SUBJECT: NEW ORCHARD FARM ELEMENTARY SCHOOL
ORCHARD FARM R-V SCHOOL DISTRICT
ST. CHARLES, MISSOURI
PROJECT # 23-09B

ADDENDUM NO. 1 PROJECT 23-09B
ORCHARD FARM R-V SCHOOL DISTRICT
NEW ELEMENTARY SCHOOL
ST. CHARLES, MISSOURI JULY 23, 2024

The drawings and specifications are hereby supplemented and amended to include the following particulars:

P2.2
SD: 12

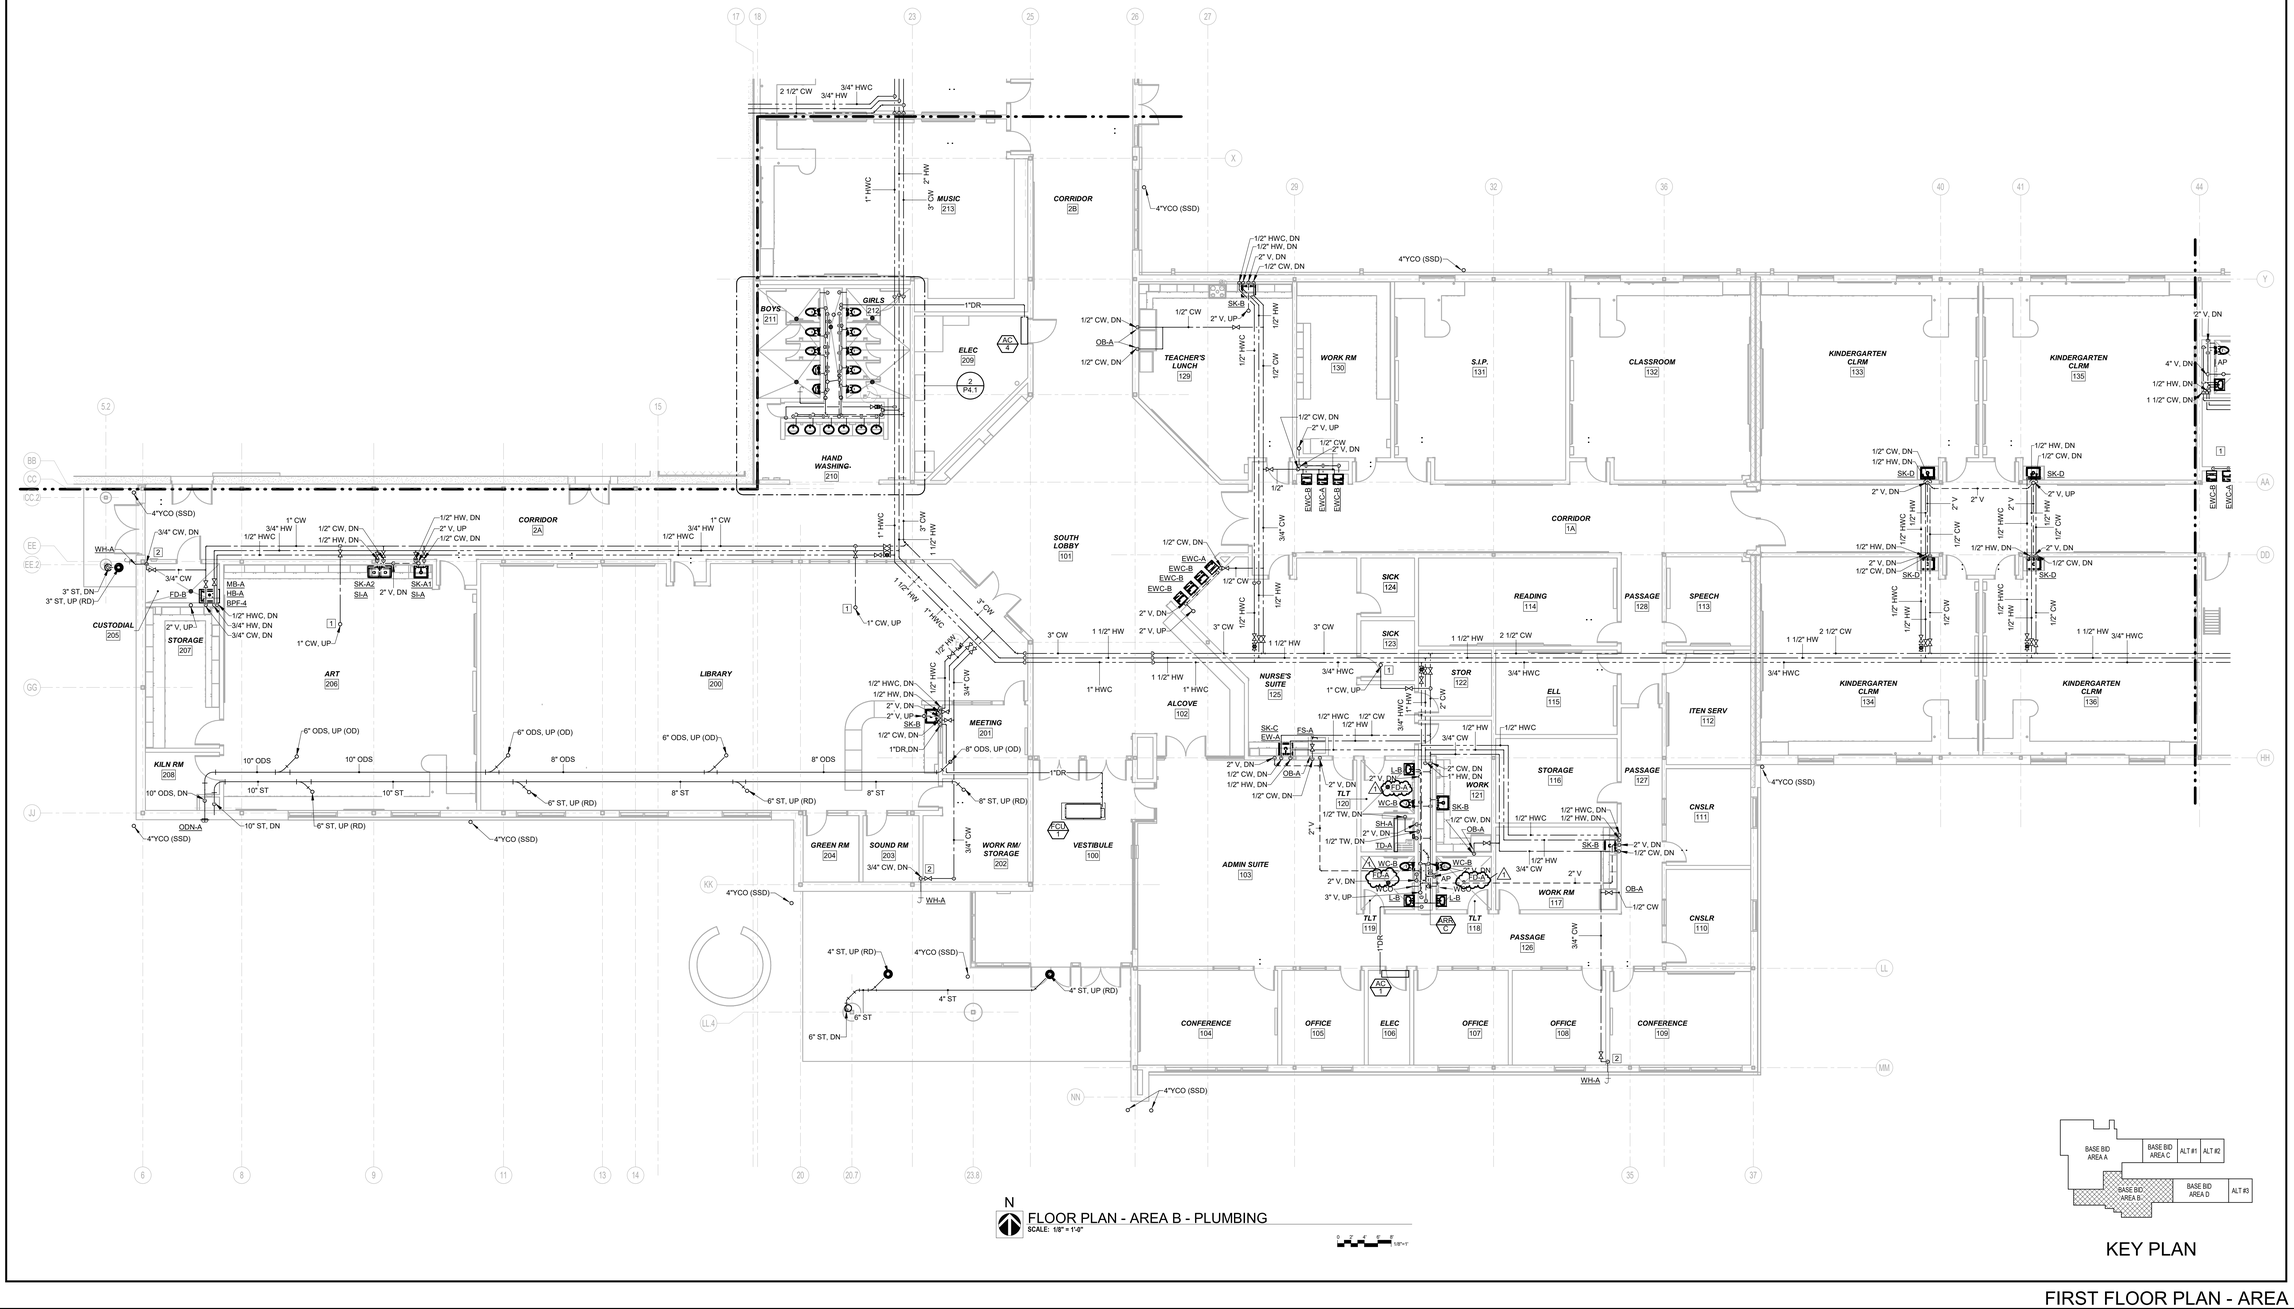
A. **"REVISE"** Floor Drain locations.

DRAWN BY Author
CHECKED BY CW
SHEET NO.
P2.3
SD: 13

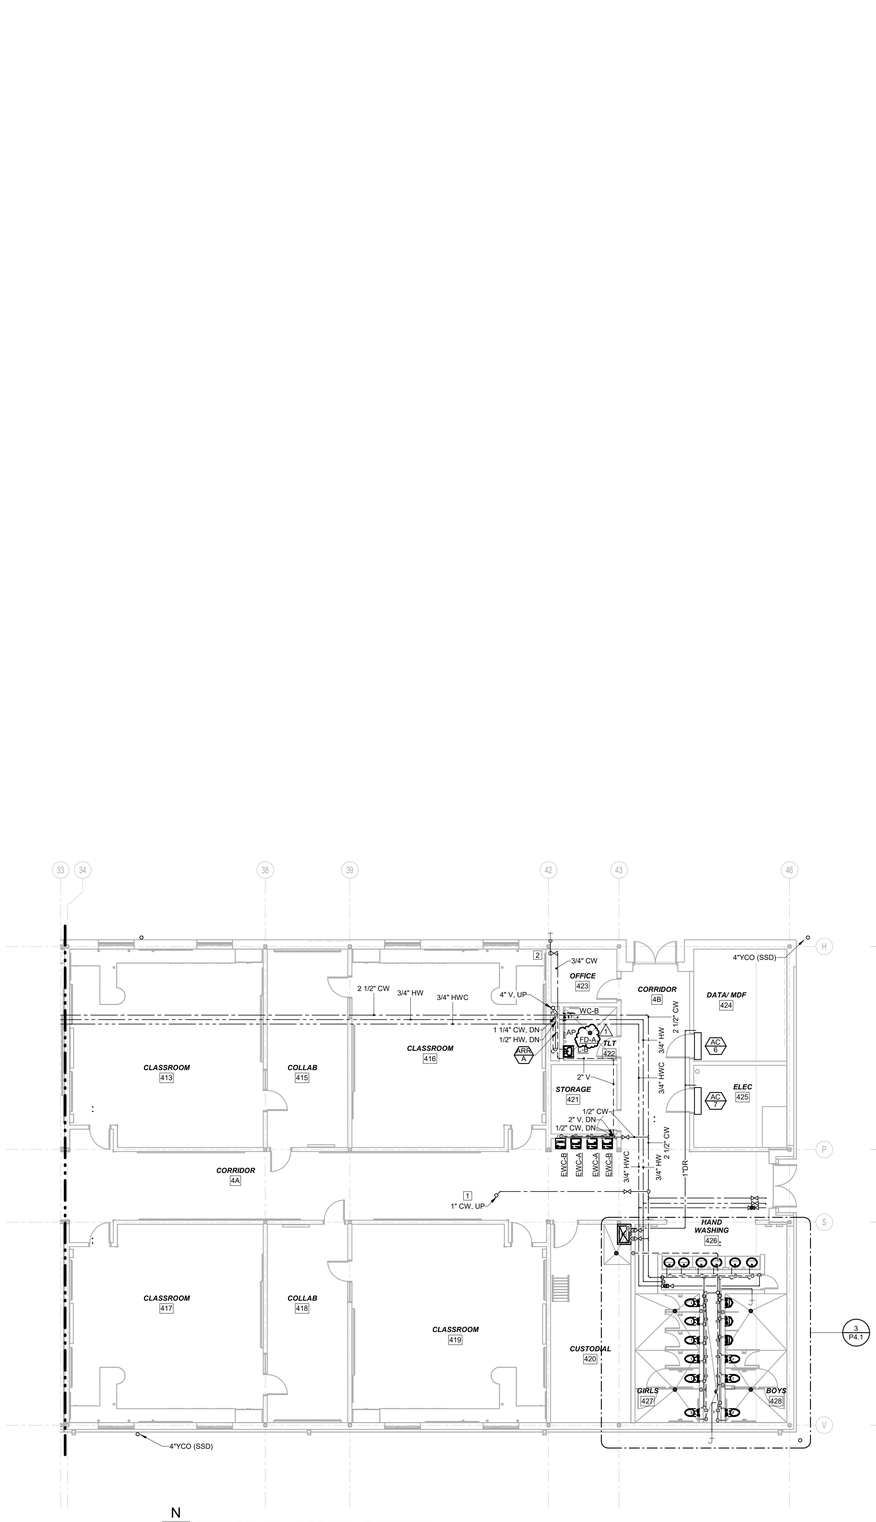
A. **"REVISE"** Floor Drain locations.

PROJ. NO.	23-09B
DATE ISSUED	
	07-02-2024
DATE	REVISION
1 07/23/24	ADDENDUM #1
DRAWN BY	Author
CHECKED BY	CW
SHEET NO.	
	P4.2
	SD: 16

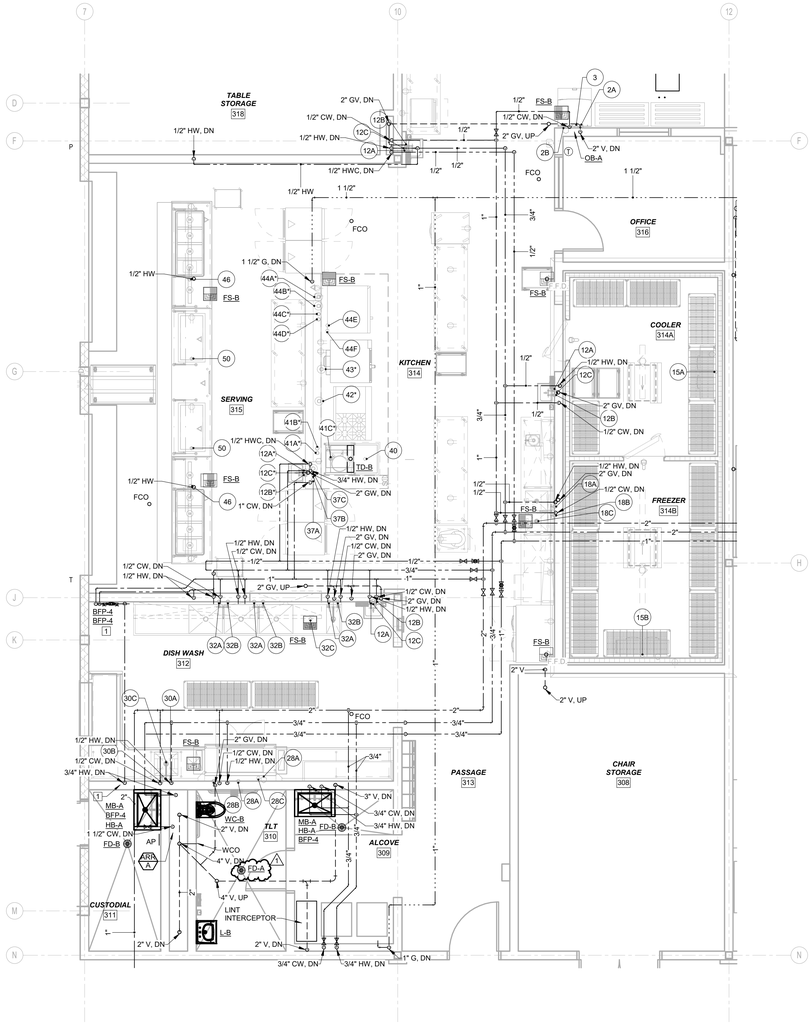
A. **"REVISE"** Floor Drain location.

E0.50
SD: 19

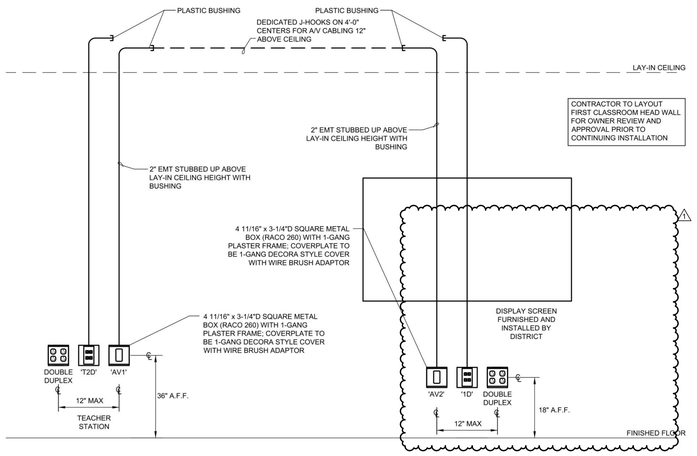
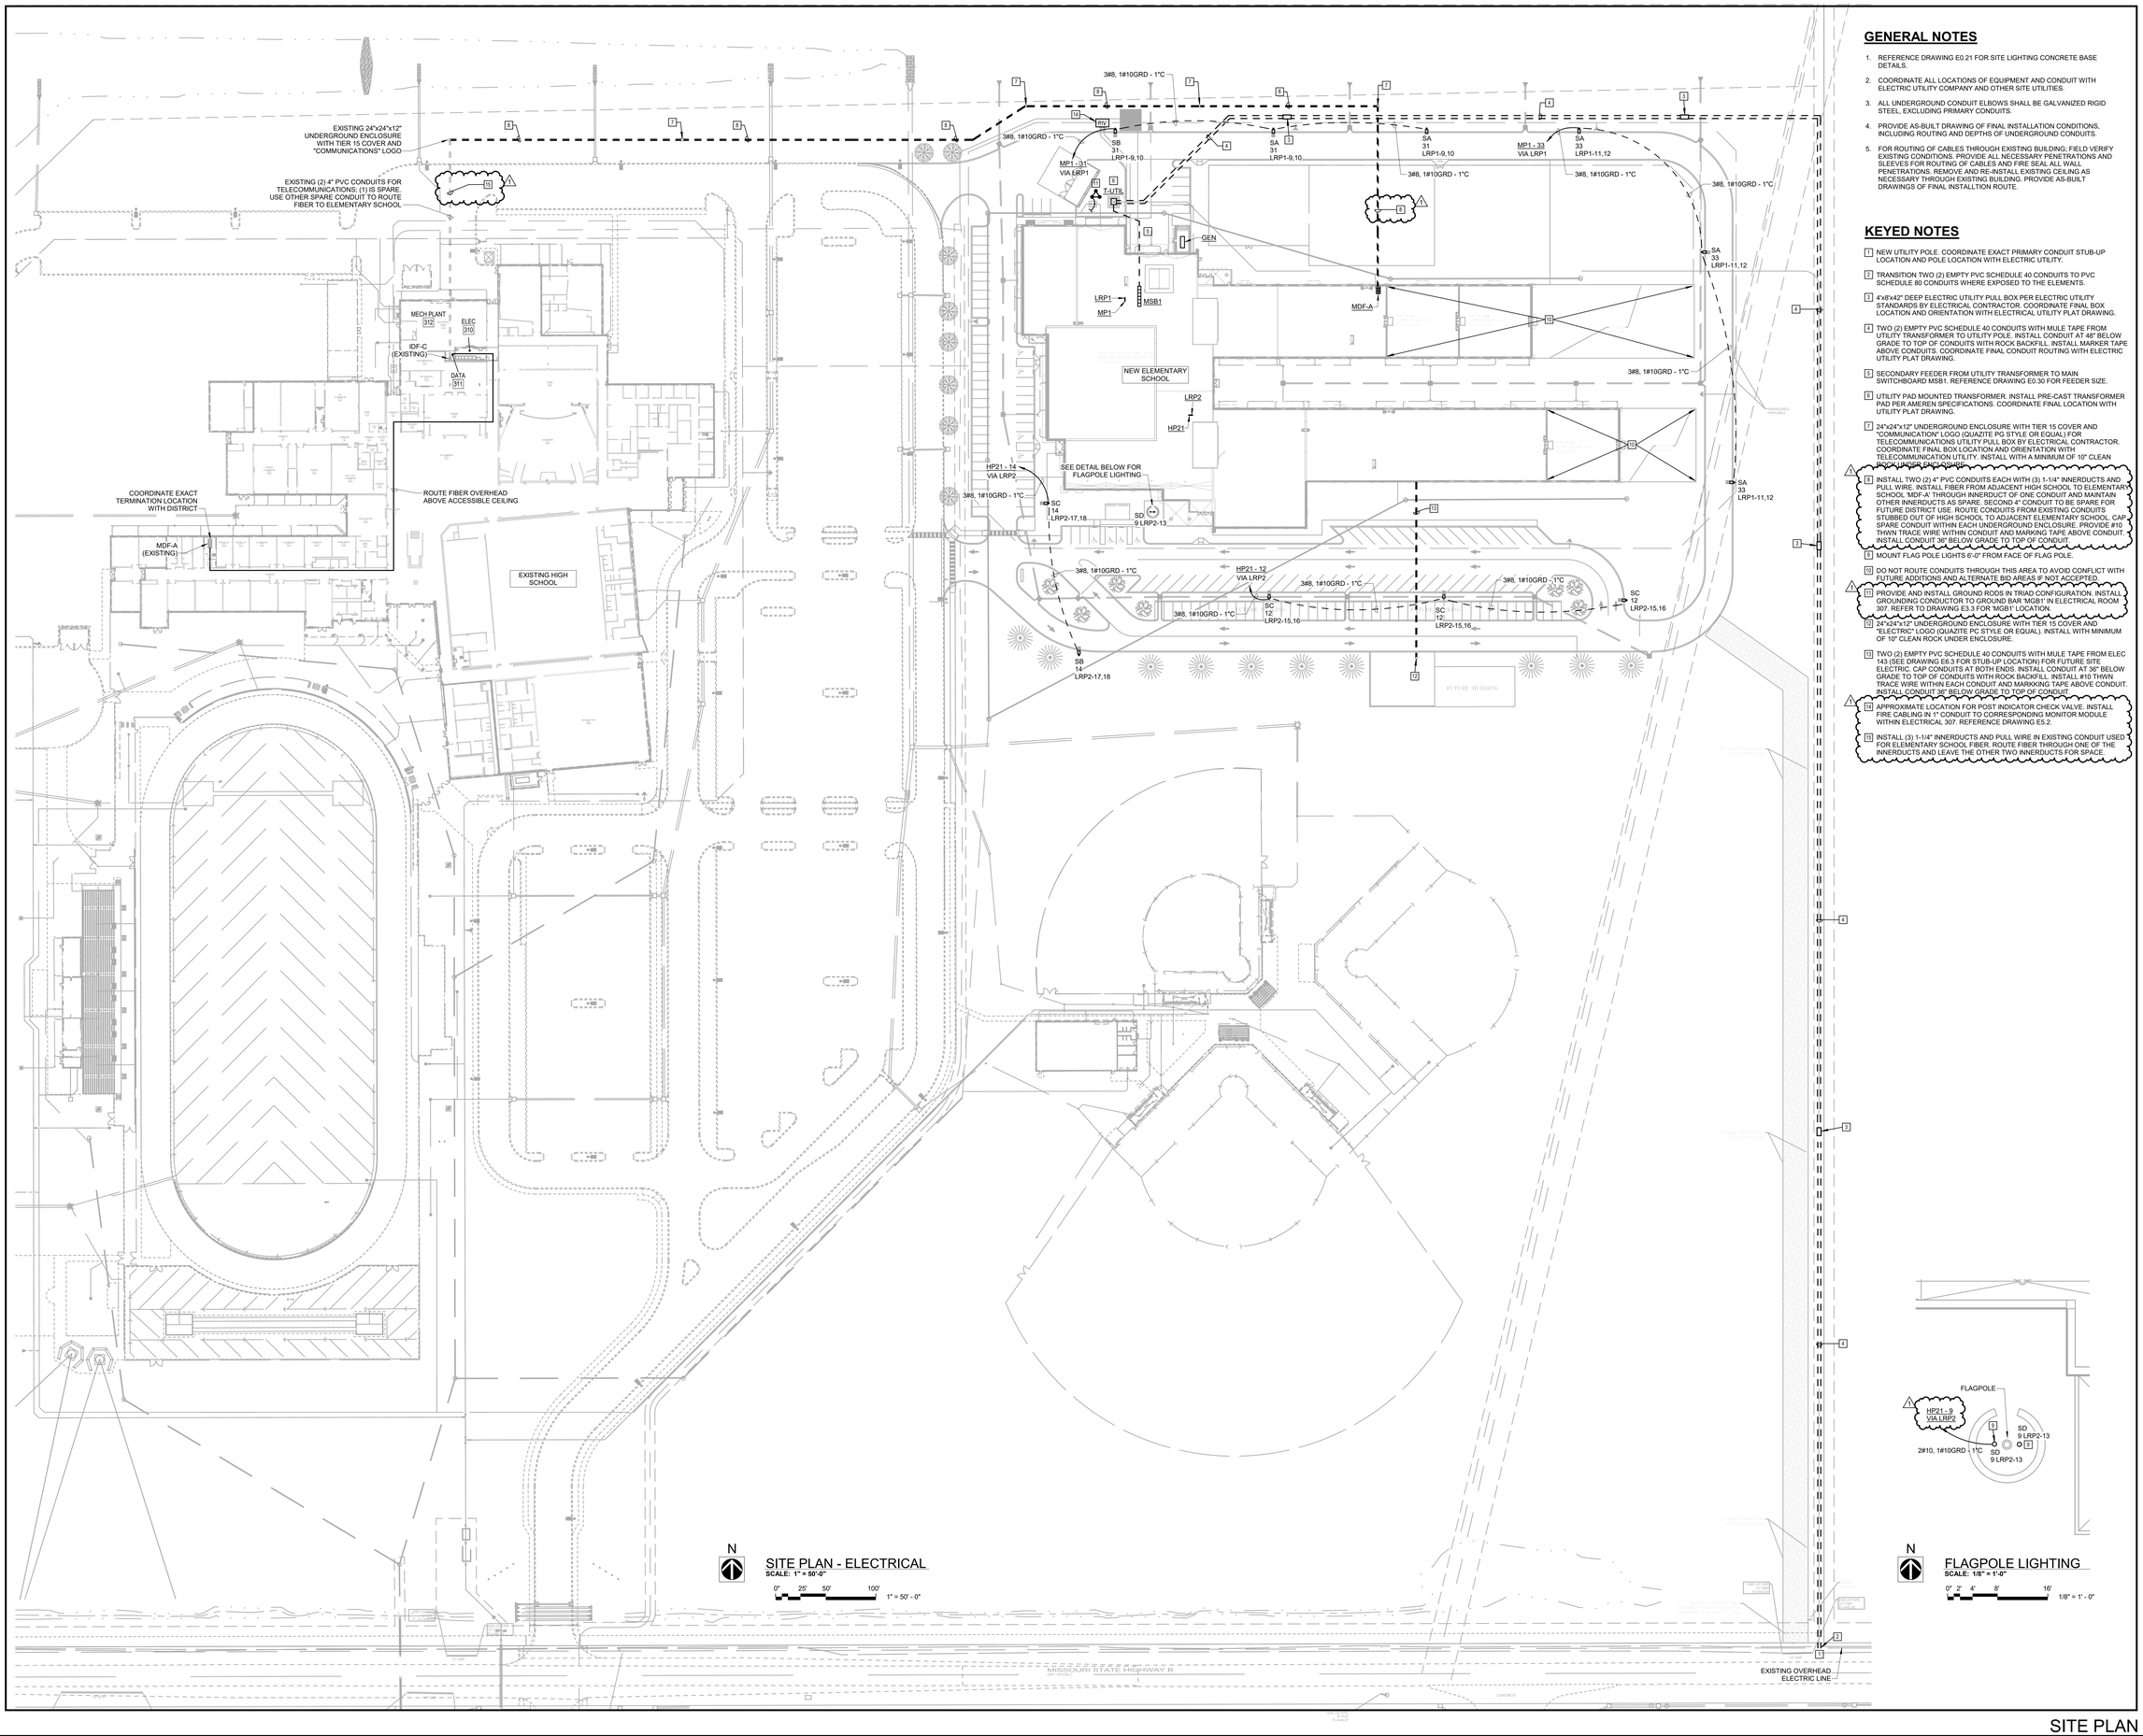
A. **"REVISE"** Low voltage responsibility matrix.
B. **"REVISE"** Typical classroom head wall rough-in.
